SI: Review of ESDI X3T9.5/87-005 Revision 1.3

I have finally completed a review of the 18 May document. It is a document which exhibits the benefits of your dedicated efforts as technical editor. I am sorry that my heavy schedule has delayed my final review of this revision. However the delay has allowed me to factor in some inputs we have received from other controller designers contemplating ZBD (ZBR, Notched), ESDI controllers.

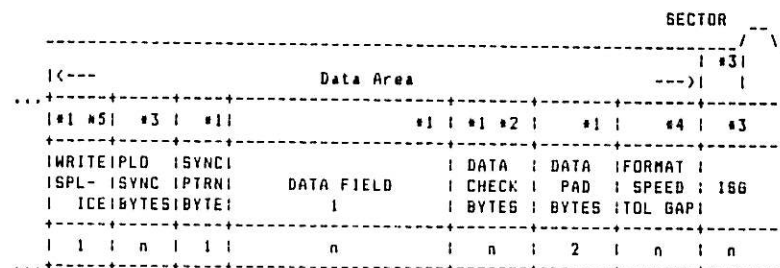
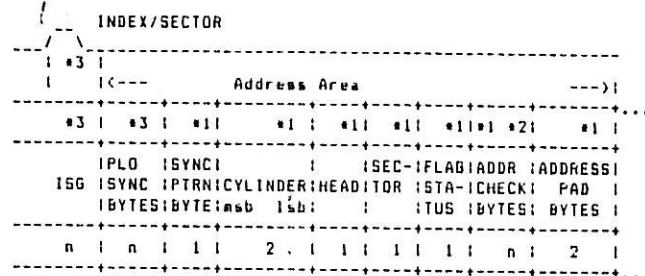
Comment: It seems safer to plan for 24 MBits/sec operation by maintaining the time called out by SMDC ANSI standard which is the same as this requirement at 10 MBits/sec. This could either be done by changing to a minimum of 500 nanoseconds or by adding a high speed port requirement. "Assuming head selection is stabilized, the time lapse from negating READ GATE to asserting WRITE GATE shall be five REFERENCE CLOCK periods minimum for drives with a Subscript 0 Configuration Response of bits 8 or 9 (0-10 MHz) or shall be twelve REFERENCE CLOCK periods minimum for drives with a Subscript 0 Configuration Response of bit 10 = 1 (0-10 MHz). If the controller requests maximum transfer rate, this value may be adjusted to any number of bits with a minimum time of 500 nanoseconds."

FIGURE 10-9 LOW SPEED PORT (0-15MHz) DISK NRZ READ DATA TIMINGS

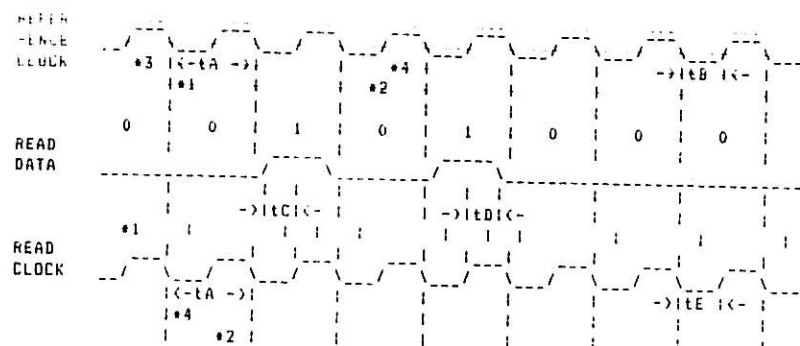
Comment: The text breaks at 10 Mhz and the timing diagrams break at 15 Mhz. Looks like we need to re-group or add an explanation.

FIGURE 10-12 HIGH SPEED PORT (10-24MHZ) DISK NRZ WRITE DATA TIMINGS

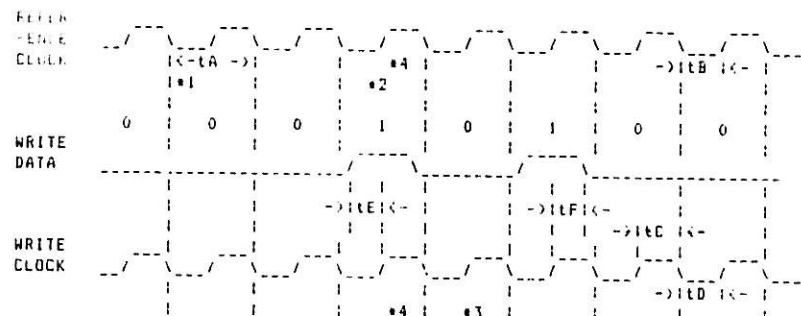
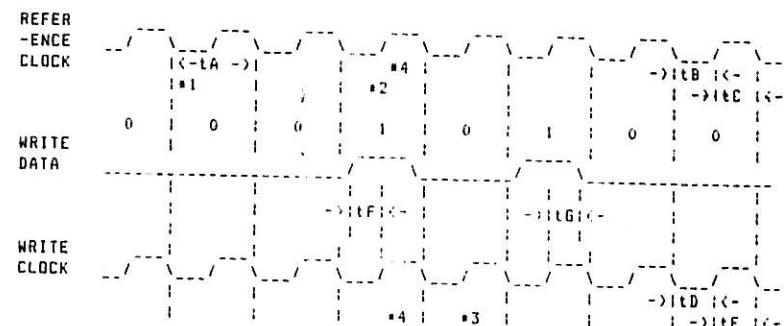
Comment: Isn't Figure 10-13 too generic for Optical? If the reference to High Speed Port makes this figure applicable to disk, the 15 periods without a clock pulse violates the ESDI requirements for disk and I think for optical.
